Shoebury Common Alternative Proposal

Technical Review

September 2013

B&V project no. 122165

SHOEBURY SEA DEFENCE PROPOSAL

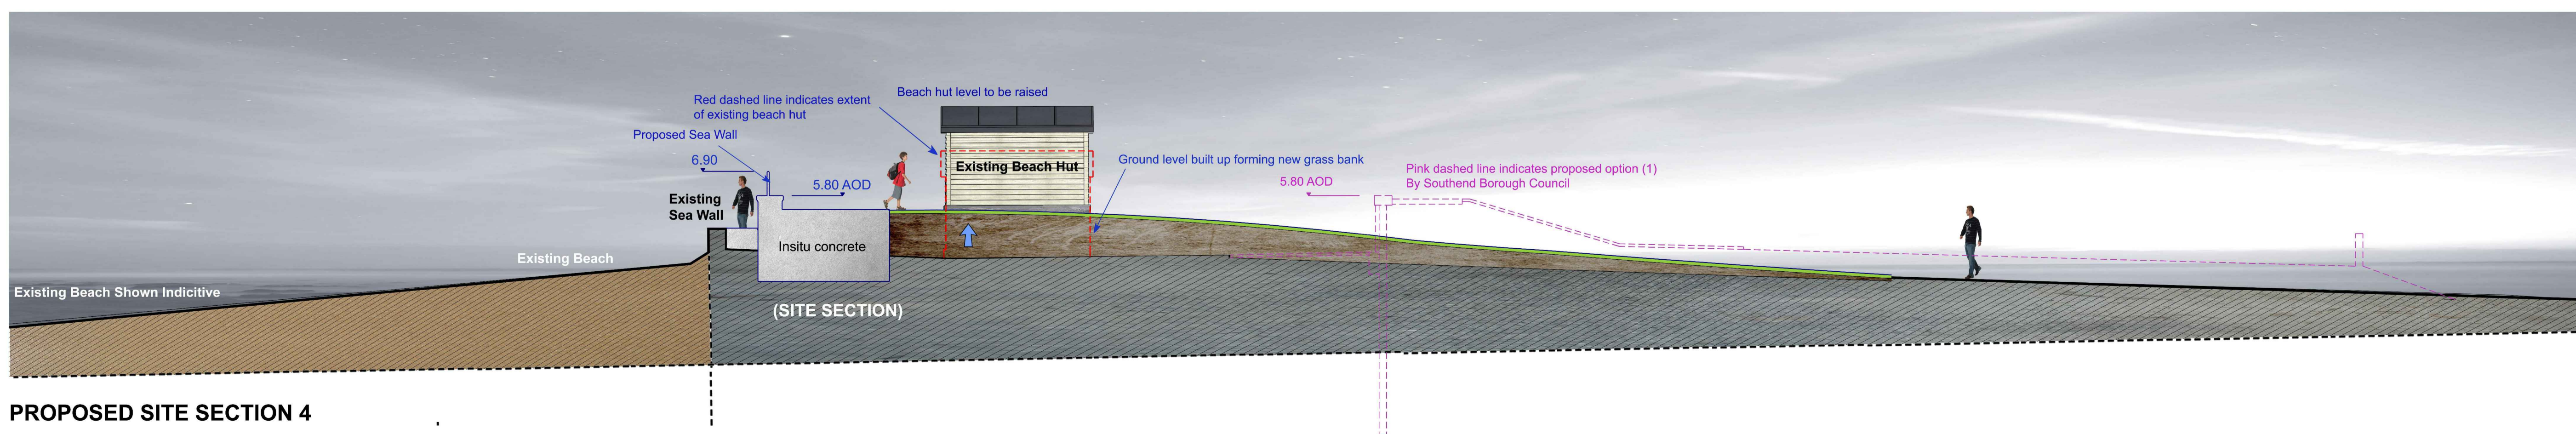
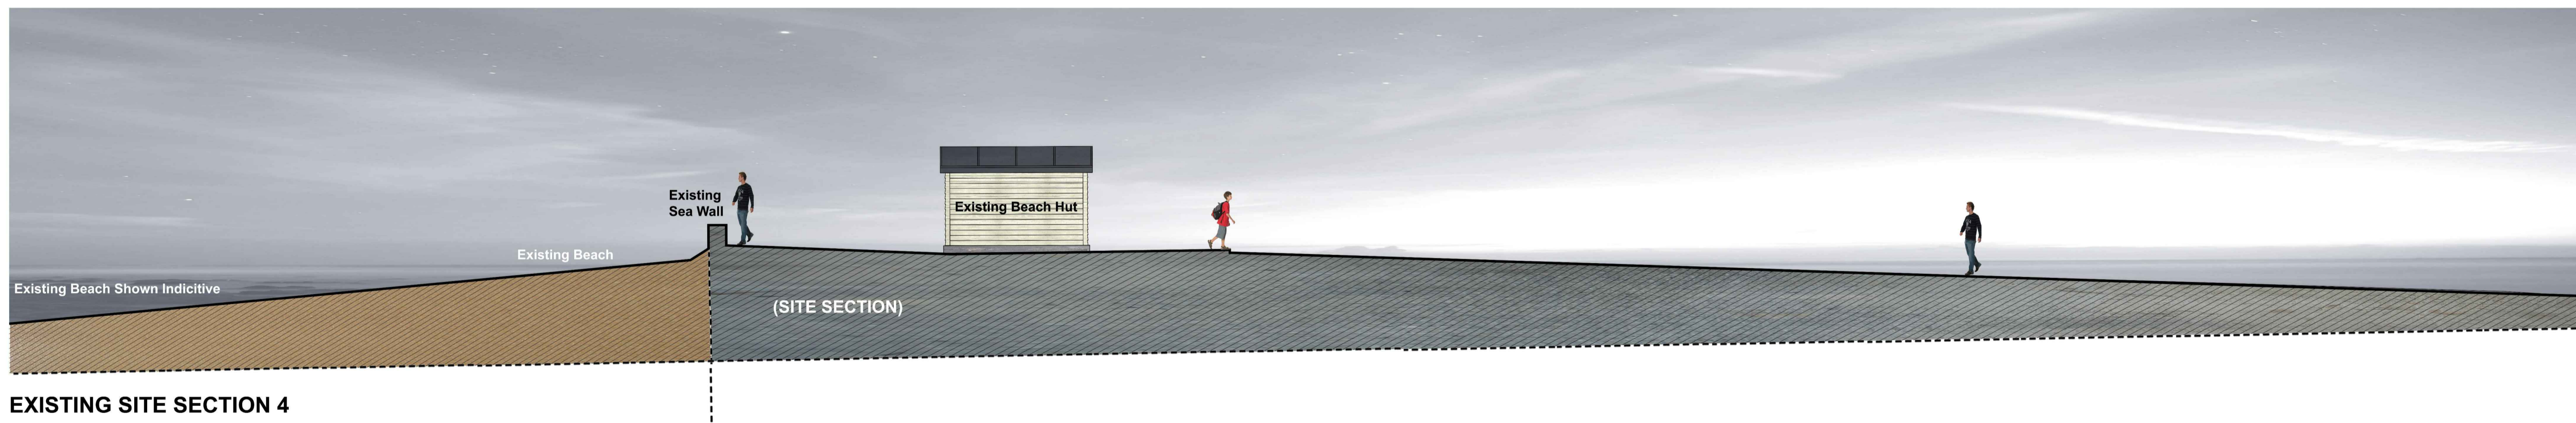
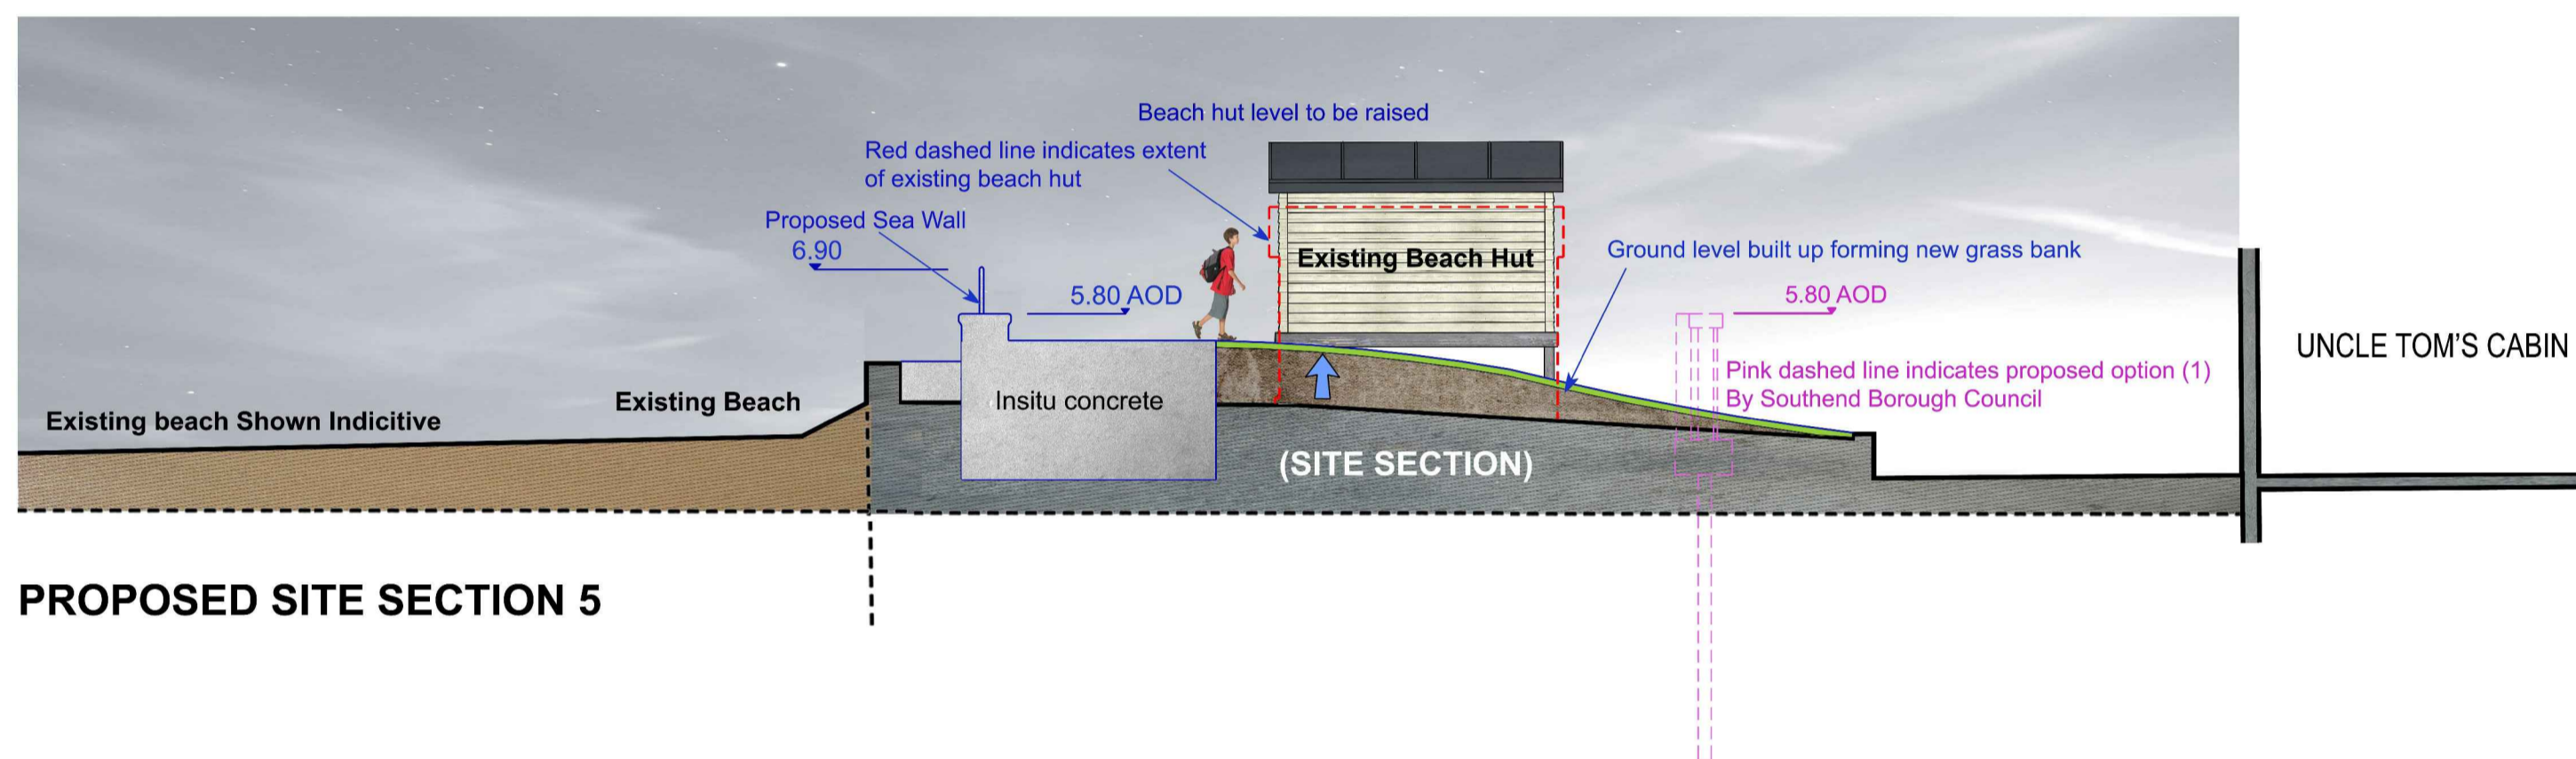
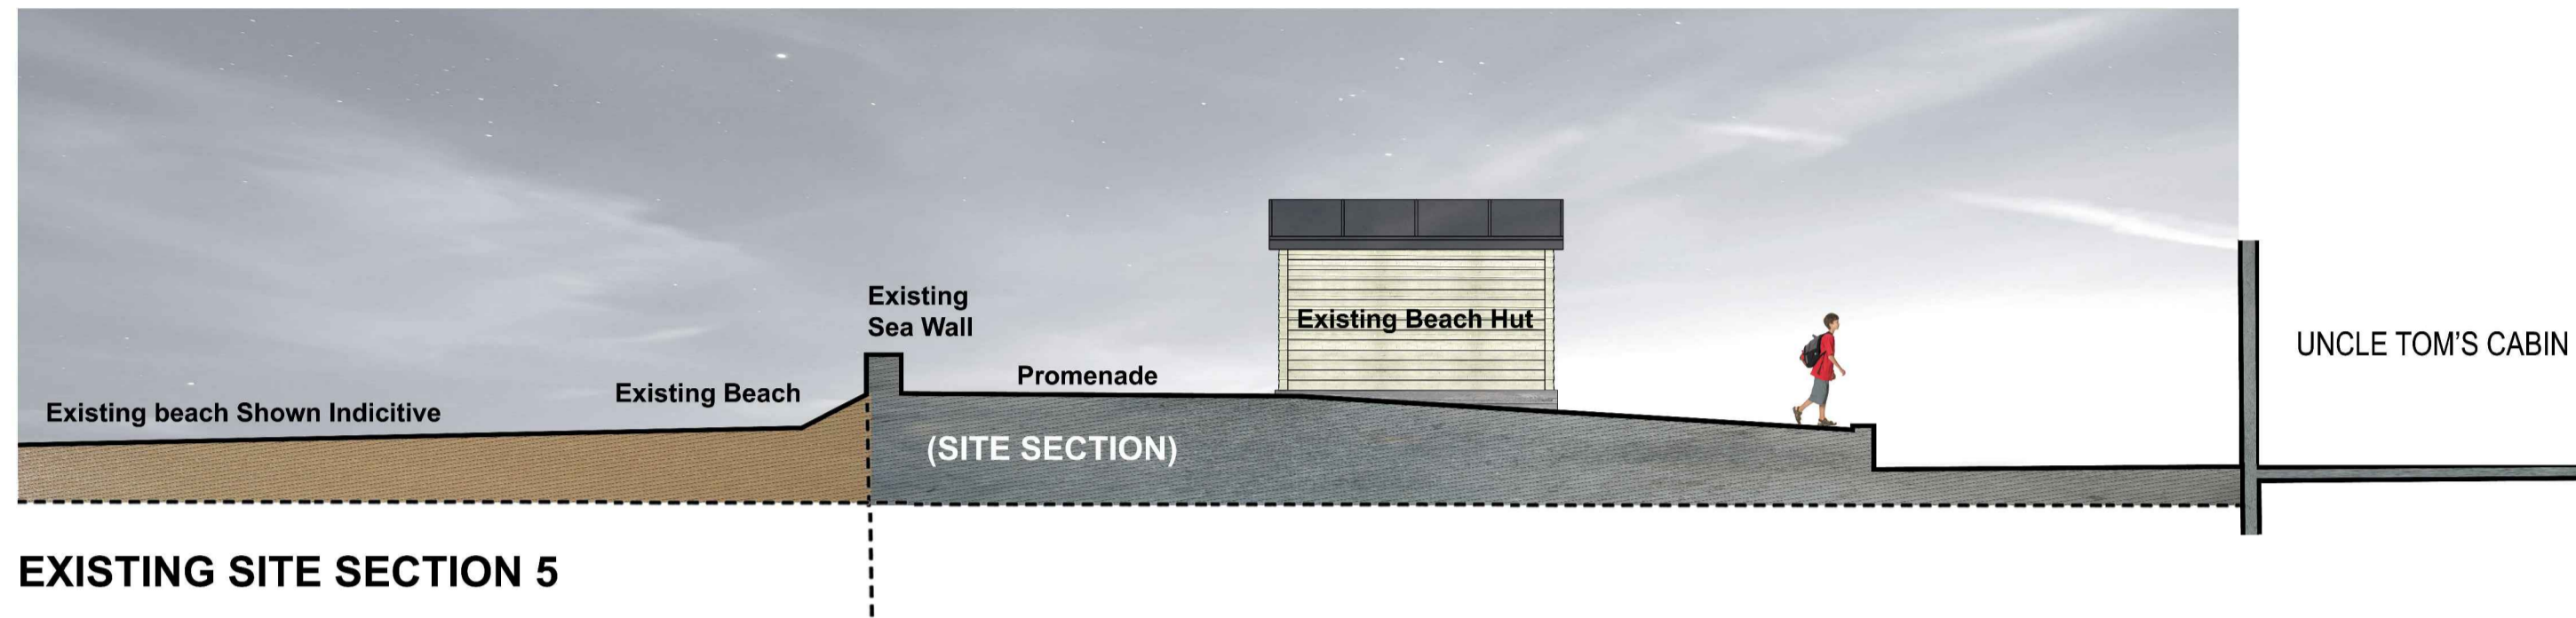
The proposals attempt to interpret and portray the Council's preferred option using pink hashing, however, it should be noted that this is an inaccurate representation of the Council's Option and should not be used by way of a comparison.

It should also be noted that the introduction of disproportionately large people (in some cases approximately 3m tall) to the drawings gives a misleading impression of the scale of the proposed works to the viewer.

Following a comparison of the proposals against the 2011 topographic survey it is clear that the levels shown within the alternative proposal are only indicative and are not drawn to a true scale.

It should also be noted that the beach levels shown on the proposals, which in some sections are shown to be approximately 4mAOD is fairly misleading as the topographic survey shows the crest of the beach to be as low as 2-3mAOD.

The proposals do not include any details of drainage, and it is not clear from the sections how the drainage of pluvial runoff will be incorporated into the scheme. It is also evident that existing surface water drainage from both the road and adjacent land behind the existing defences will be affected by the proposed scheme.

The proposals currently show a grassed and graded (imported) material slope down from the elevated promenade providing access to Uncle Tom's cabin. However, closer inspections of the levels provided by a 2011 topographic survey indicate that this slope will be approximately a 25% gradient (1 in 4). A slope of this gradient is not in line with the latest

guidance for disabled/wheelchair access, which recommends a maximum gradient of 5% (1 in 20) with resting platforms every 10m. Therefore the proposal will in effect inhibit the use of this access point for the disabled and wheelchair users.

- The proposed access from the proposed level of the promenade to Uncle Tom's Cabin (Cafe) in Section 5 is shown as a gently sloping gradient. However, following a comparison between the existing ground levels and those proposed it is clear that the required slope will be steeper than that depicted in the Section and it will not conform with the latest guidance for disabled/wheelchair access.

SHOEBURY SEA DEFENCE PROPOSAL

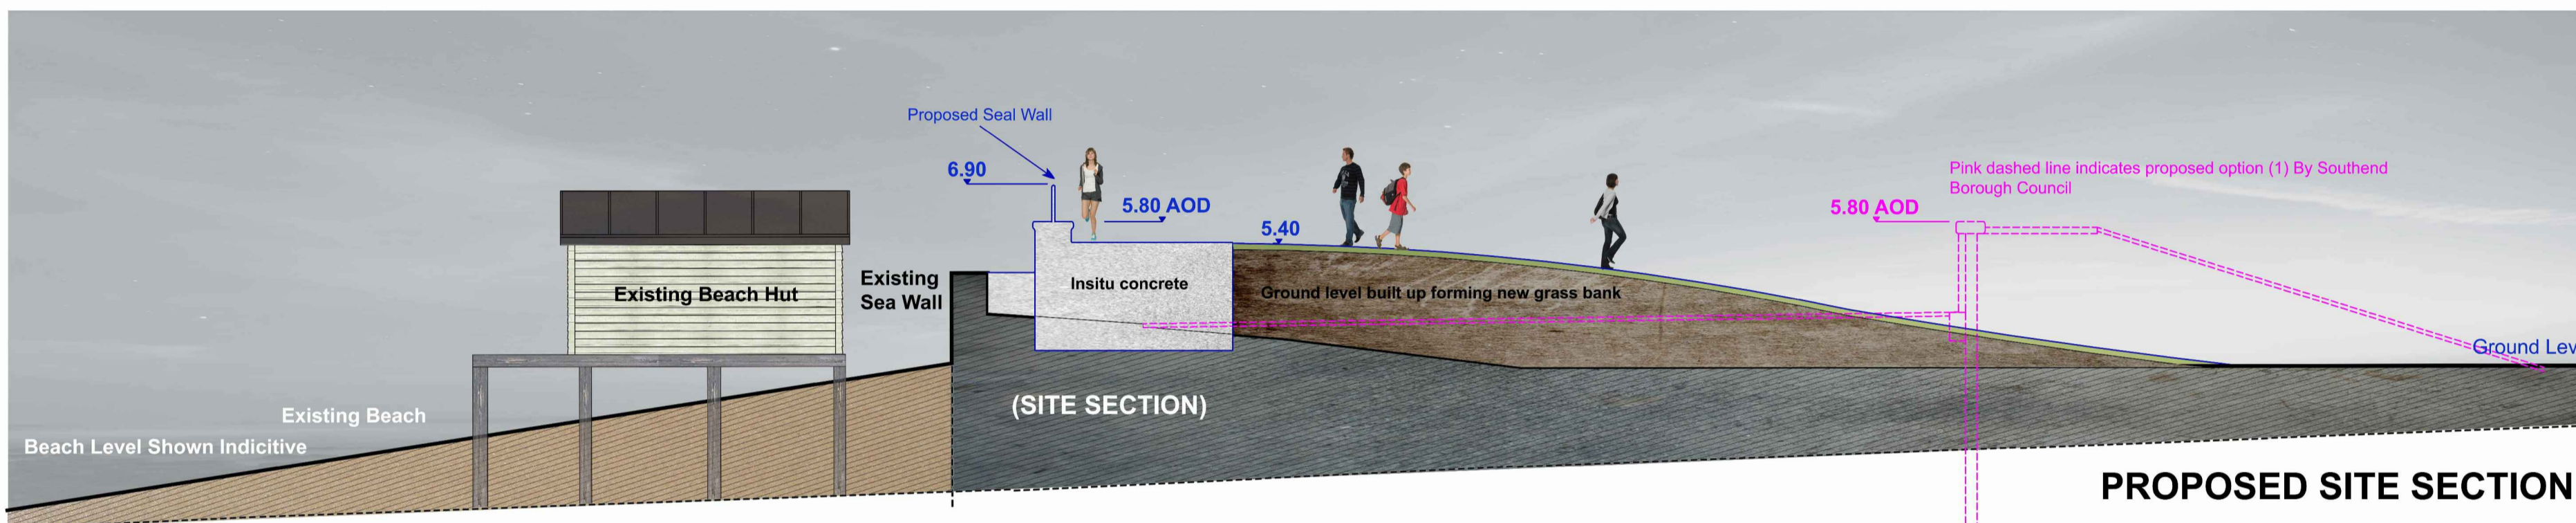
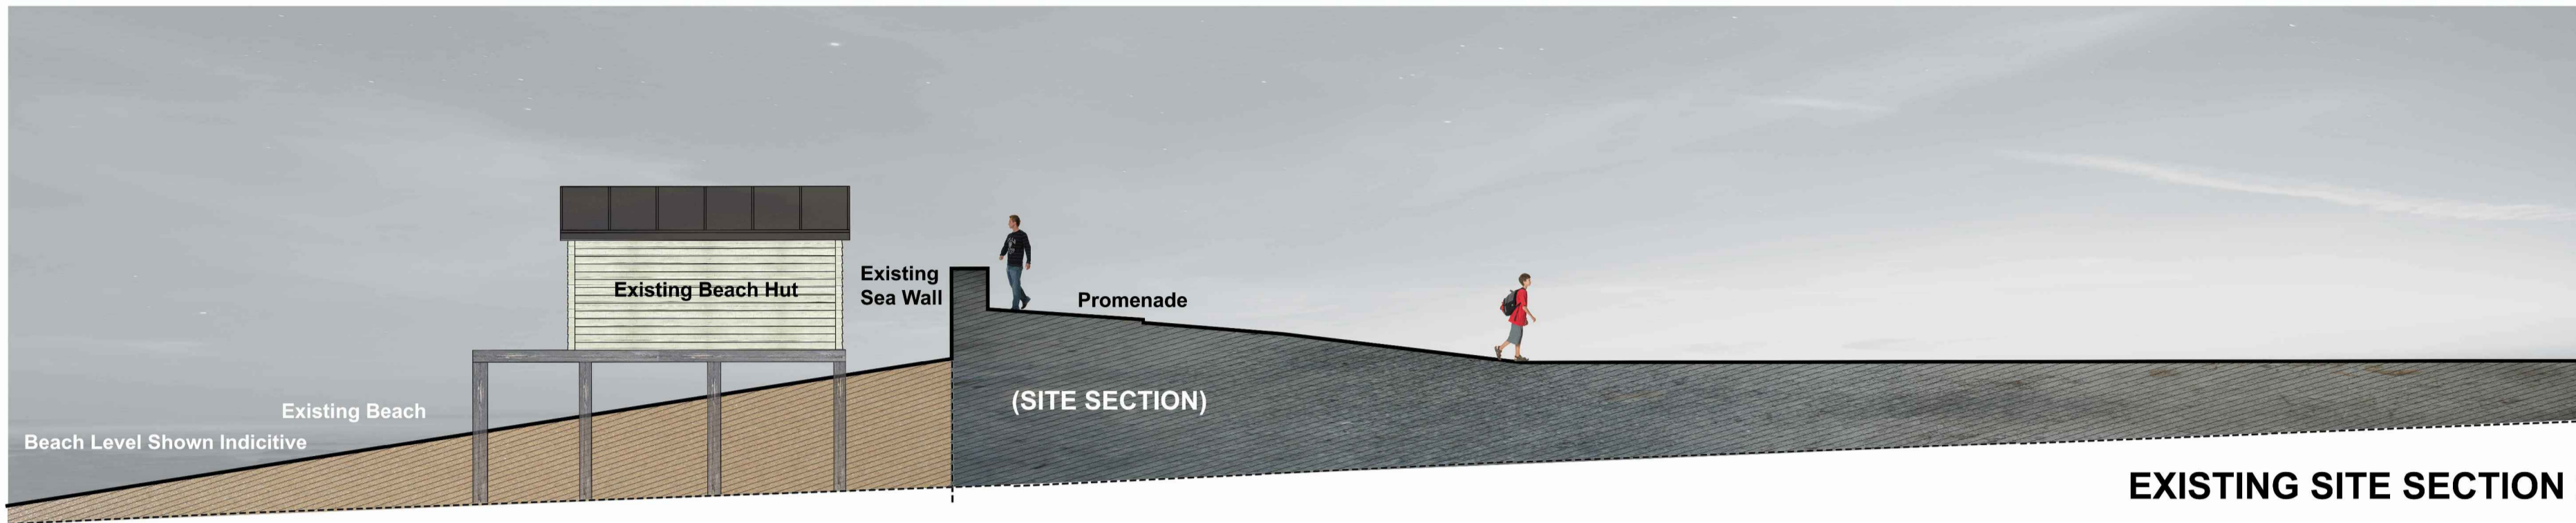
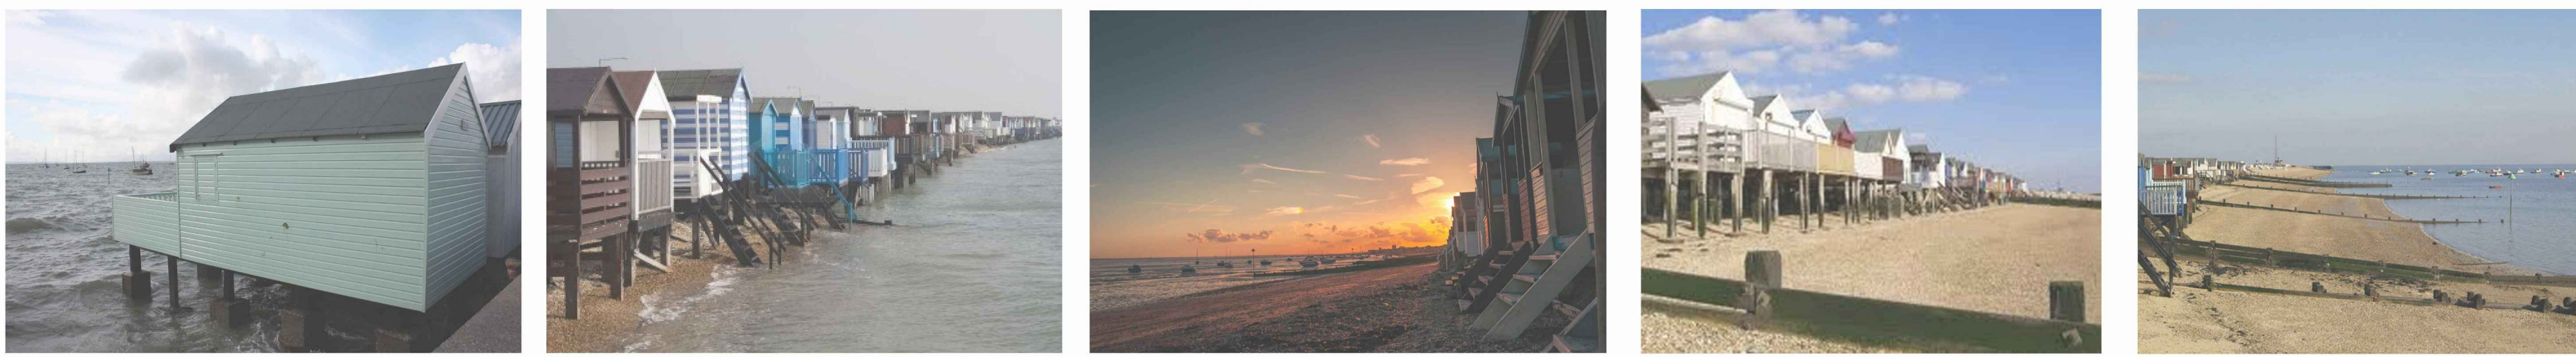
Section 5 is also the similar to Sections 3 and 4, but this section of the defence is in front of Uncle Tom's Cabin (cafe) and requires the landscaping to include a 1 in 4 (25%) slope to provide access to the promenade from the cafe.

It should also be noted that the actual beach levels are not as depicted in the proposal drawings and are subject to natural variations due to coastal processes and can therefore not be guaranteed to provide the required lateral support over time.
